DEPARTMENT OF THE ARMY SAN FRANCISCO DISTRICT, U.S. ARMY CORPS OF ENGINEERS 1455 MARKET STREET SAN FRANCISCO, CALIFORNIA 94103-1398

Mr. Bruce H. Wolfe Executive Director San Francisco Regional Water Quality Control Board 1515 Clay Street, Suite 1400 Oakland, California 94612-1413

The United States Army Corps of Engineers, San Francisco District (Corps) appreciates the opportunity to officially comment on the final Tentative Order for waste discharge requirements (WDR) for the Berryessa Flood Risk Management Project (Project). As you know, the San Francisco Regional Water Quality Control Board (RWQCB) already issued a Clean Water Act (CWA) section 401 Water Quality Certification, Pub. L. No. 92-500, as amended, 33 U.S.C. § 1341, on March 14, 2016, (401 Certification) for this Project. And, in reliance on the conditions contained therein, the Corps has awarded a construction contract to complete this necessary flood risk management project. Therefore, the Corps strongly takes issue with the untimely WDR conditions and any indication from the RWQCB that Congress has waived sovereign immunity with regard to the Porter-Cologne Water Quality Control Act, thereby allowing the RWQCB to n

Figure 2: Berryessa Historical Longitudinal Profile (Piedmont to I-680 from Jordan 2009)

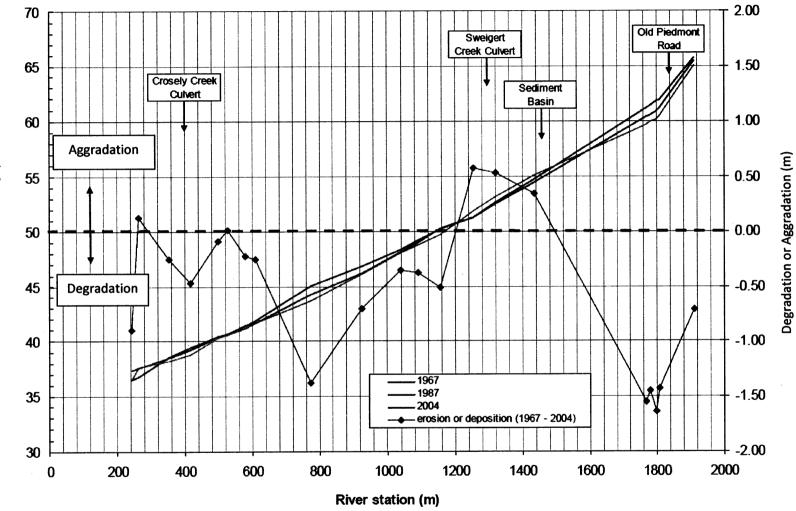
In the study, Jordan compared historical construction drawings from the District², as well as from the US Army Corps³, with a 2004 survey of the channel profile. The findings show a generally degradational trend for the creek from the 1960's to the mid 2000's for Berryessa Creek reaches upstream of I-680 (Figure 2).

Finding 26 – Water Quality Control Plans:

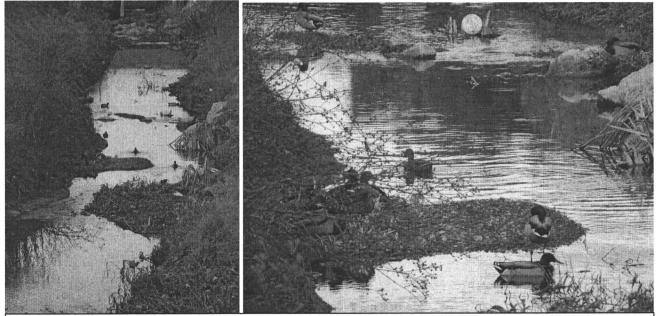
The finding discusses naming conventions of the National Wetlands Inventory for mapping wetlands. The discussion mentions that significant portions of Upper Berryessa Creek are riverine wetlands, and lists features such as inset Page 4 of 7 12-5-16 TO/WDR/WQC Upper

Figure 4. Distinguishing features and examples of habitats in the Riverine System.

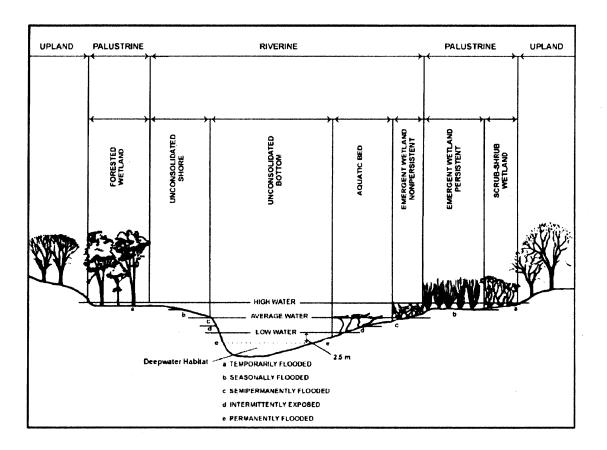
Third, even if the National Wetlands Inventory classification system were an appropriate reference, it makes clear that areas above the high-water mark are uplands, *not* riverine or wetlands:

If the riverine zone is below the high-water mark, then the areas above that mark cannot be named as riverine wetlands.
